HISTORIC AND DESIGN REVIEW COMMISSION

August 03, 2016

HDRC CASE NO: 2016-308
ADDRESS: 2215 W MISTLETOE
LEGAL DESCRIPTION: NCB 6829 BLK 0 LOT E 40 FT OF 52 W 26 FT OF 53
ZONING: R6 H
CITY COUNCIL DIST.: 7
DISTRICT: Monticello Park Historic District
APPLICANT: Torres & Co Roofing and Remodeling
OWNER: Jose Sanchez
TYPE OF WORK: Window replacement
REQUEST:

The applicant is requesting a Certificate of Appropriateness for approval to remove 24 one over one wood windows and install 24 insulated aluminum windows.

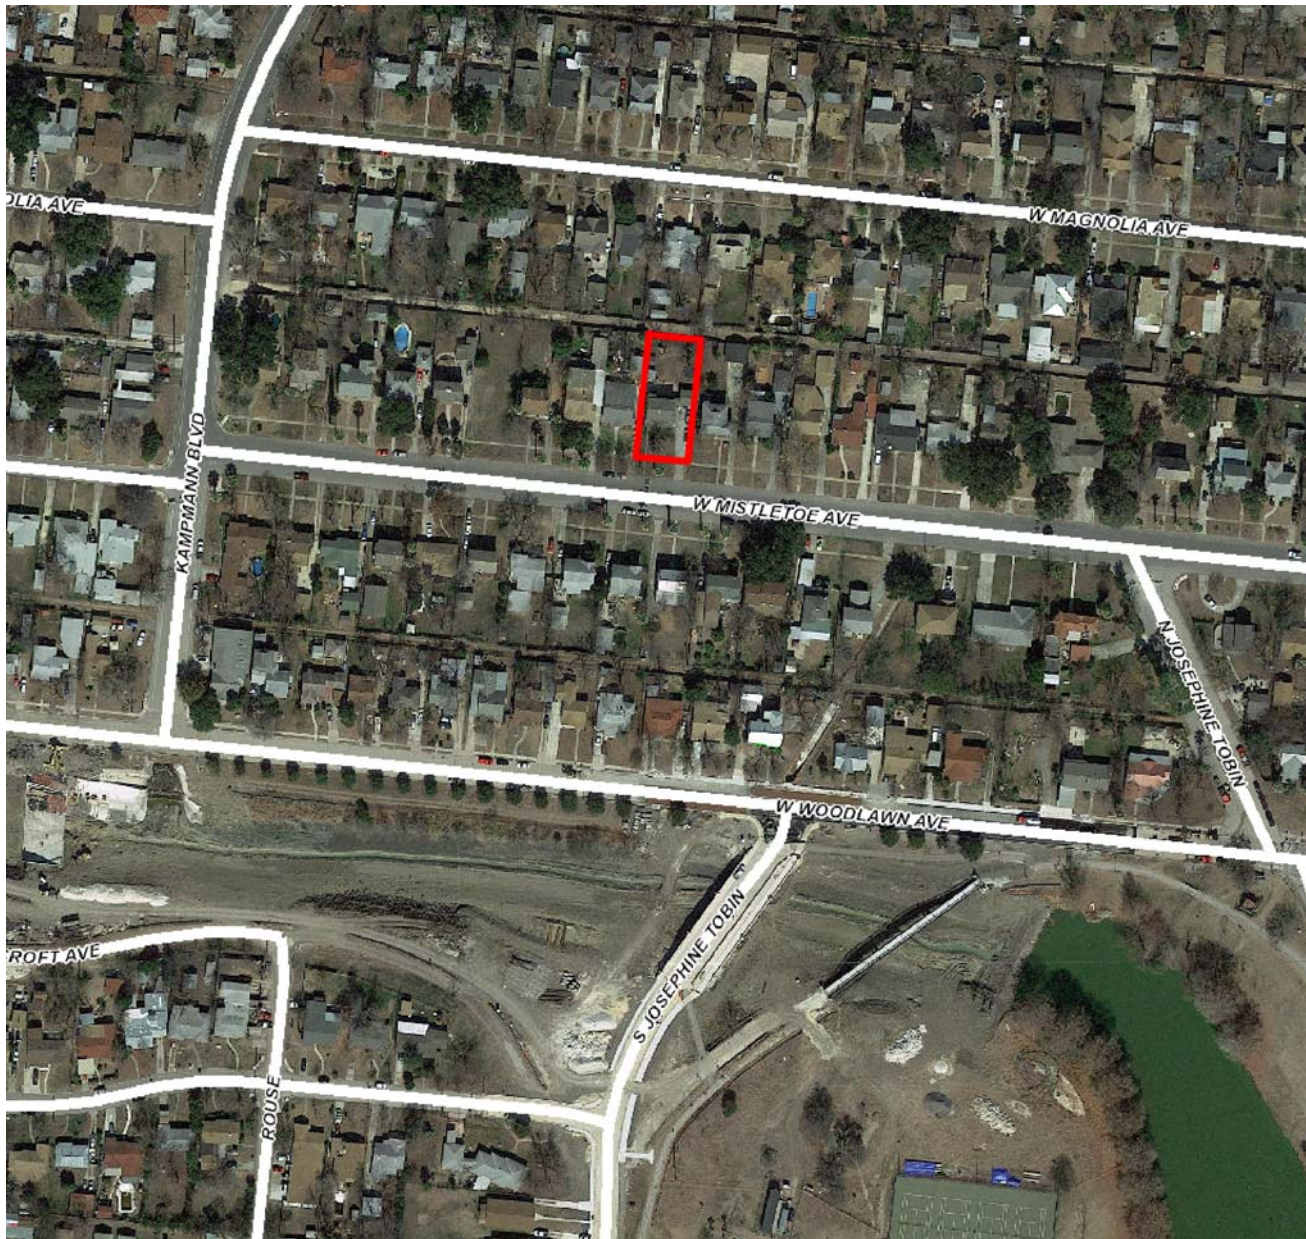
- a. The home at 2215 W Mistletoe is located in the Monticello Park Historic District, and was designated January 27, 2008. The home is a folk Victorian, cross-gabled, with composition shingles, and with a front porch with wrought iron posts.

- b. The existing windows are double hung wooden one over one windows. The applicant is proposing to remove 24 windows and install single hung aluminum one over one windows. According to the Guidelines for Exterior Maintenance and Alterations 6.B.vii., historic windows should be repaired or, if beyond 50% deteriorated, should be replaced with a window to match the original in terms of size, type, configuration, material and details, feature clear glass, and recessed within the window frame. Windows with a nailing strip are not recommended. The corresponding pages from the adopted windows policy document have been added to the exhibits for this request. Staff made a site visit July 22, 2016, and found the windows in need of repair but repairable. Staff finds the proposal not consistent with the Guidelines. Windows are an important character defining feature, therefore, staff recommends that they are retained and repaired.

Staff recommends denial based on findings a and b. Staff recommends the existing windows be repaired.
